EPA 330/9-74-003

*Engineering Evaluation
of the
Main Water Quality Control Plant
Stockton, California*

DECEMBER 1974

MAIN WATER QUALITY CONTROL PLANT
SLUDGE LAGOONS AND PUMPING STATION

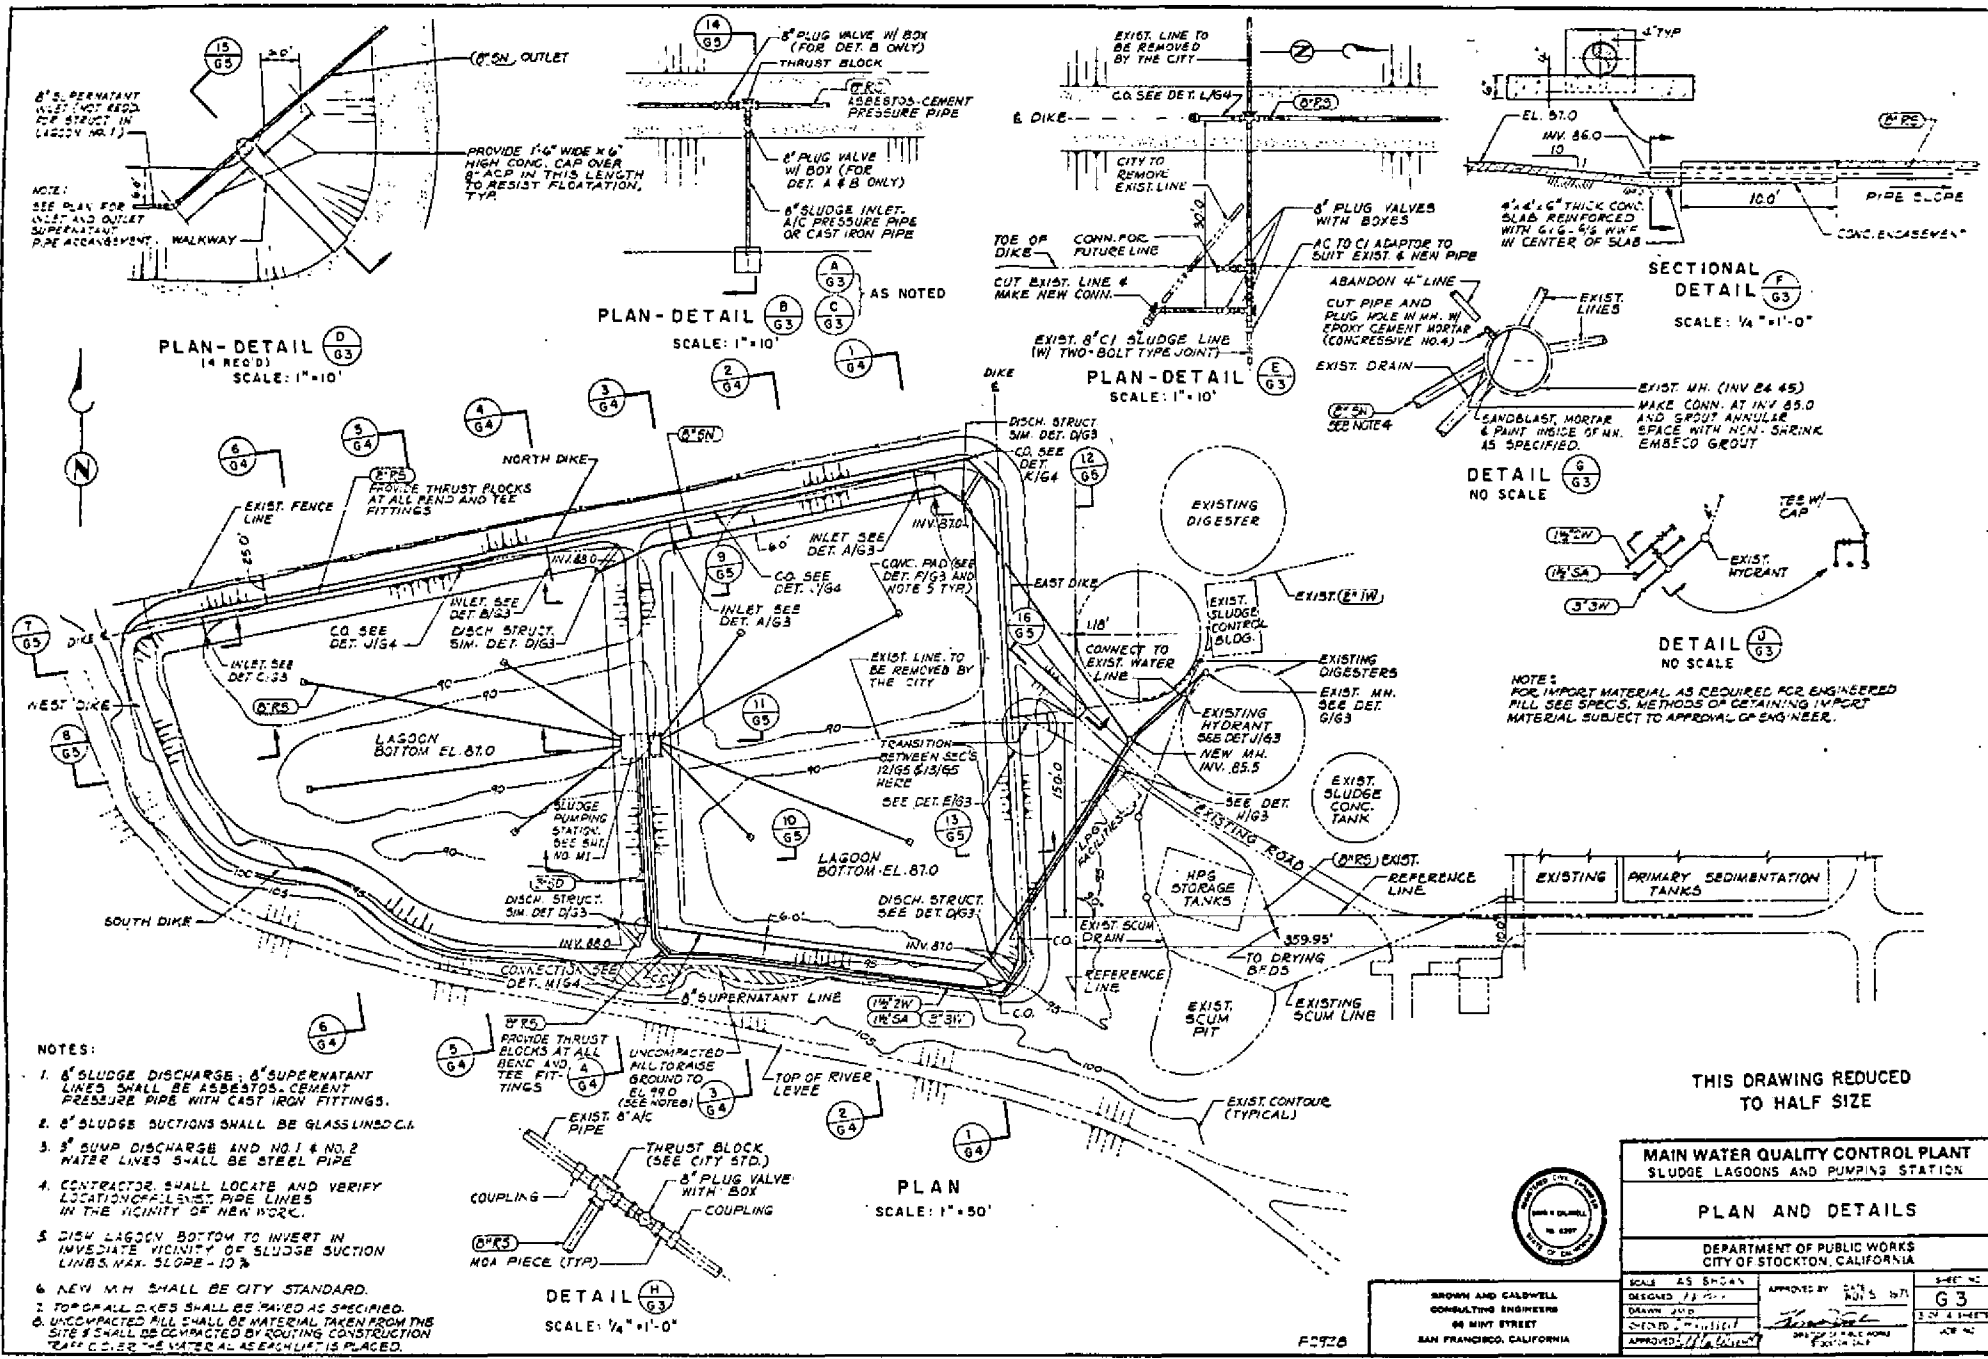
The plan view and section 1/M1 of the sludge pumping station are from Sheet M1 of the contract plans and specifications (Appendix). The eight 8-inch diameter pipes pass through the east and west walls of the pump station (four pipes through each wall) at a centerline (CL) elevation of 85.00. These eight pipes are the sludge drawoff pipes from lagoons 1 and 2. Just inside the station walls, each pipe is connected to an 8-inch diameter pipe Y with a victaulic cap and coupling on the Y leg.

Provisions were made by the design engineers to bring City water and compressed air to the pumping station structure. A two-inch water line is tapped into the lagoon sludge drawoff piping. It is common practice at treatment plants to use compressed air and/or water pressure to blow out sludge lines which are not excessively clogged. Plant personnel report that this technique has been already utilized with success on this piping. However, pressure gages should be installed on the backflush piping so that the operators can evaluate the back pressure being applied to the clogged pipe.

For a fail-safe design, the cleanouts should have been routed above the surface elevation of the lagoons or valved upstream. Due to the structural configuration of the pump station, it would be difficult to revise the existing piping to accomplish this. Also, since there are no isolation valves on the cleanouts, it would be difficult to connect extensions to the existing cleanouts without flooding the structure.

Three items of concern about the air and water piping systems are listed below. One, no connection to an air supply is indicated on the drawings. Rather, the terminus of this pipe is indicated as a cap located near the existing City water hydrant (Detail J/G3, Contract Drawing G3). Two, a hose bib or coupling is not specified on the sludge suction piping which could be used for connection from the existing air line to the clogged sludge suction line. Three, a vacuum breaker in the 2" water line connection to the sludge piping is not indicated between the sludge-piping connection and the City water hydrant. A cross connection is thus developed by this design and the potential for back siphonage of lagoon contents into the City water supply does exist.

Sump Pump - The sump pump referred to is located in the southwest corner of the sludge pumping station (Contract Drawing M1). Its function is not to pump sludge, but to remove from the station any spills, wash-up water, foundation leakage, etc. which may be collected by the floor drain system.

The discharge piping from this sump pump (pipe 3"SD) is routed overhead in the station, through the south station wall, under the berm roadway between the two lagoons, and tied in the 8" supernatant line from lagoon No. 1's southeast telescopic weir (Detail M/G3 on Drawing G4). The sump pump is thus supposed to discharge the station sump contents through this line to the 8" supernatant line which was originally designed for gravity flow.

As a possible solution, a special cap and isolation valve could be installed on the leg of the Y and eliminating the vitraulic cap. The special cap would require packing around the cleanout port to allow use of a cleaning rod. However, since the cleanouts would only be used in rare instances, modifications are not warranted at this time.

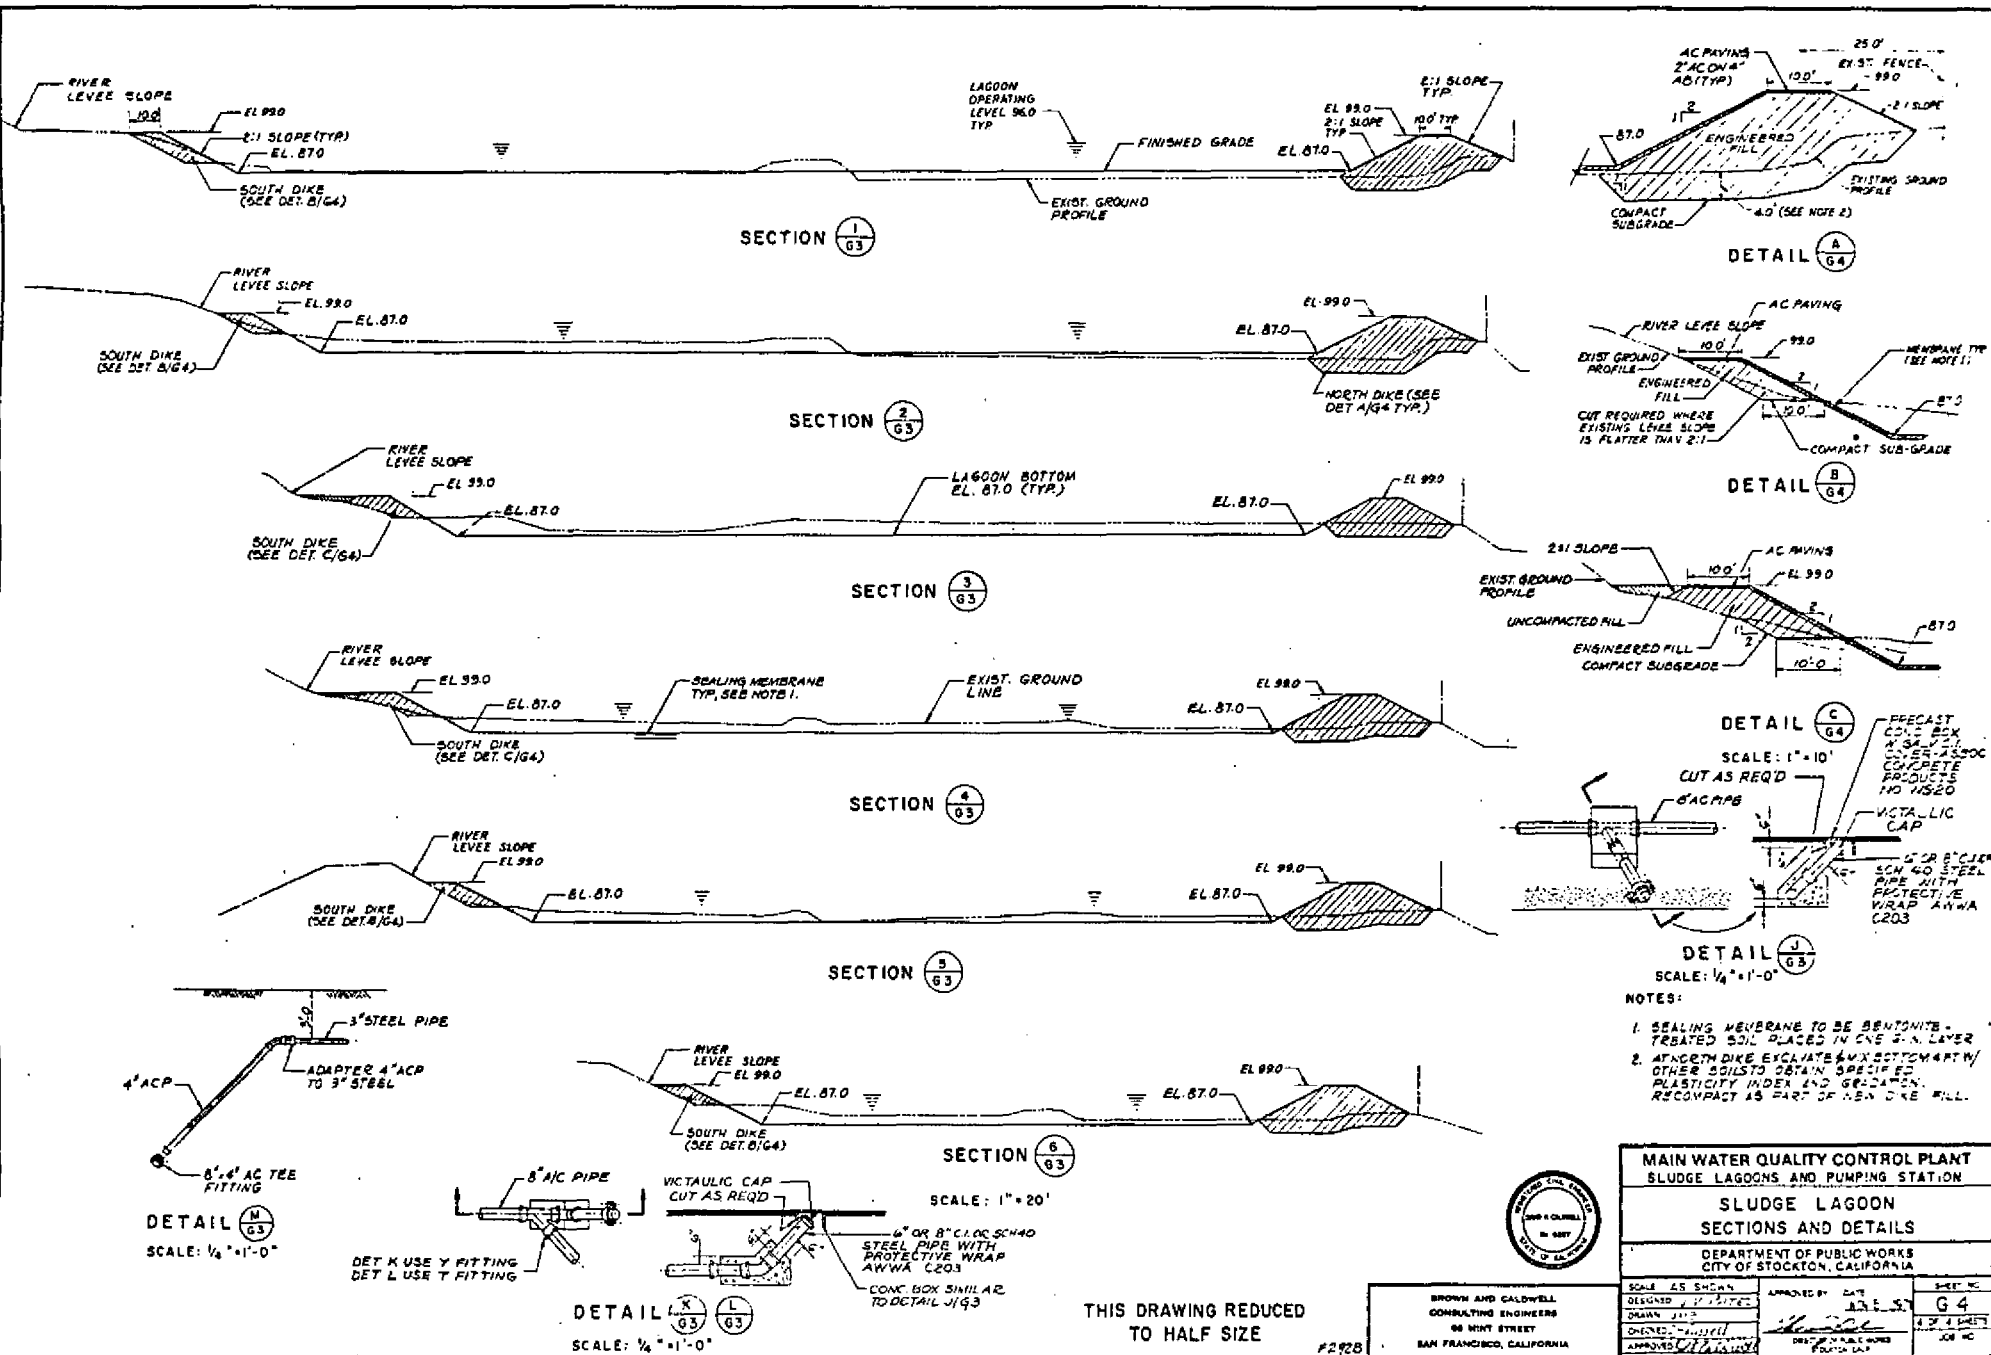
Detail A/G5, Contract Drawing G5, (Appendix) illustrates the design of the four telescopic weir units. The discharge weir unit has a specified outside diameter of 29-7/8 inches and is to fit inside a riser pipe with an inside diameter of 30 inches. A fabrication note on Section 1/G5 specifies that the weir and riser pipe should be "Fabricated for uniform clearance of 1/16" plus or minus 1/32" over the entire circumference." This tolerance is apparently specified to permit the weir to move within the riser pipe without binding and yet minimize the leakage between the two components when the weir unit is positioned above the minimum adjustable height.

This operational flexibility is dependent on the weirs not leaking appreciable quantities of water through the annular space between the weir unit and the riser pipe. When such leakage does occur, and the leakage rate exceeds the lagoon influent rate, it becomes impossible to maintain the lagoon surface elevation above El.94.0, the top of the riser pipe, by use of the telescopic weirs.

The contractor (C. N. Peterson Company) tried to correct the weir leakage problem with gaskets previous to the installation (by the City) of the valves. These gaskets failed and caused operational problems due to binding. The City plans to weld a stainless steel cap ring onto the riser pipe. This ring will have an inside diameter $1/8$ inch larger than the field measured outside diameter of the corresponding weir unit. Post modification testing of the individual weirs will determine if the leakage problem is sufficiently reduced to eliminate further design modifications. It is our understanding that the City will bear the expense of the cap ring modification since the contractor paid the City for the installation of the valves. In our opinion, if the modifications achieve the specified $1/16" \pm 1/32"$ clearance between the ring cap and weir, the contract requirements will be satisfied.

If the ring cap modifications for the lagoon telescopic weirs do not solve the leakage problem, the consulting engineer should be brought to task for improper design and required to change the weir design to solve the problem.

MAIN WATER QUALITY CONTROL PLANT
MODIFICATIONS TO SECONDARY TREATMENT FACILITIES
TRICKLING FILTERS NO.4, NO.5 & NO.6
SECTIONS

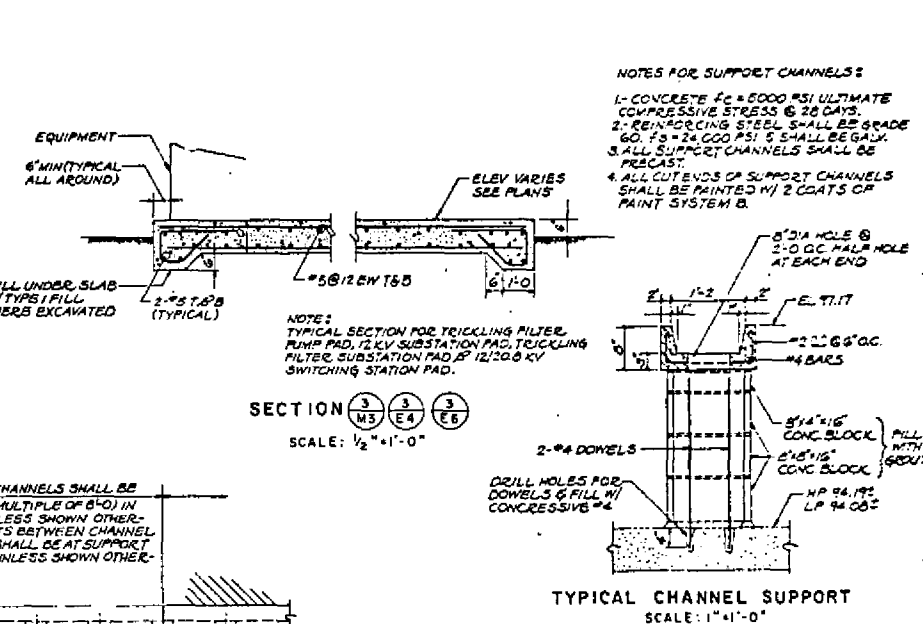
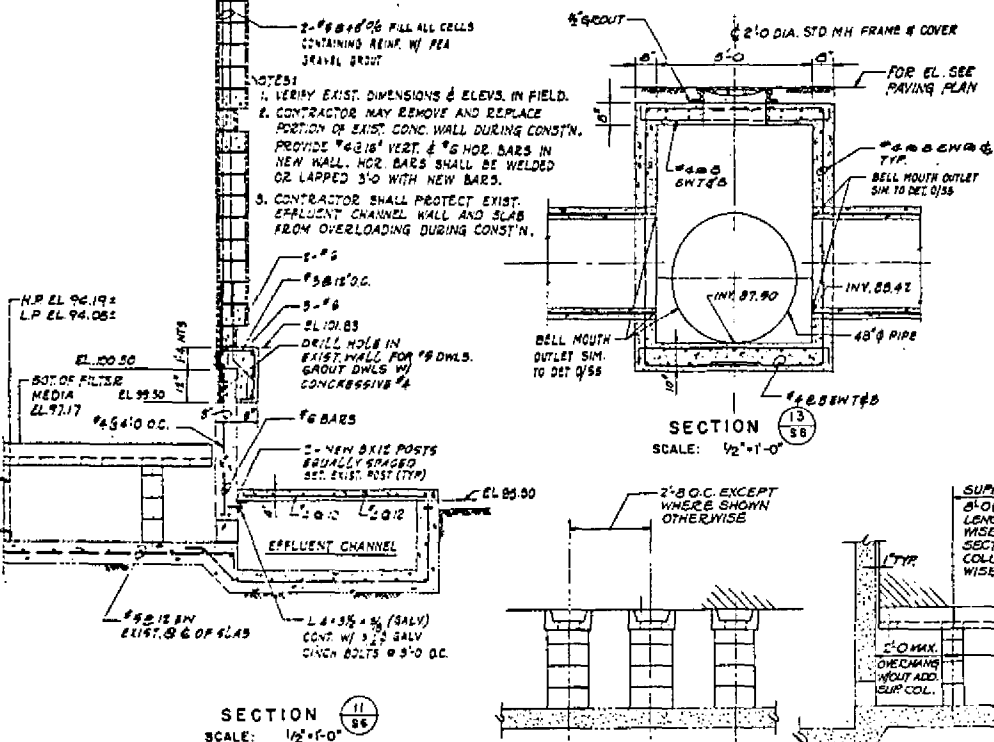
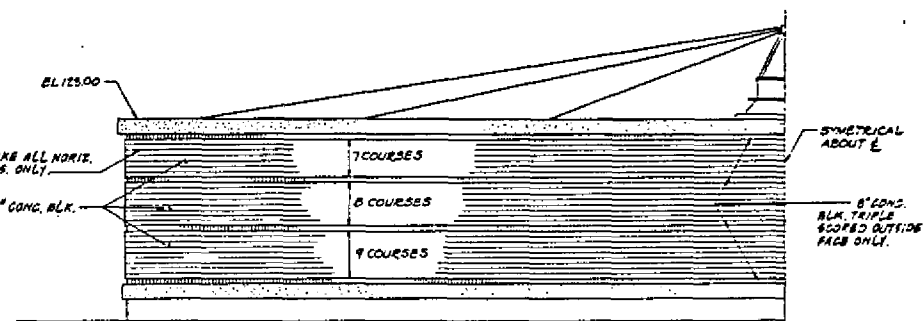
Details of the wall construction are shown by Drawing Sheet No. S 7 trickling filters Nos. 4, 5, 6 sections.

As determined by a review of the drawing and construction pictures and questions of inspectors and the resident engineer, the walls were constructed as per specs and drawings. However, as previously discussed in Question B-2, the leakage is a result of design error.
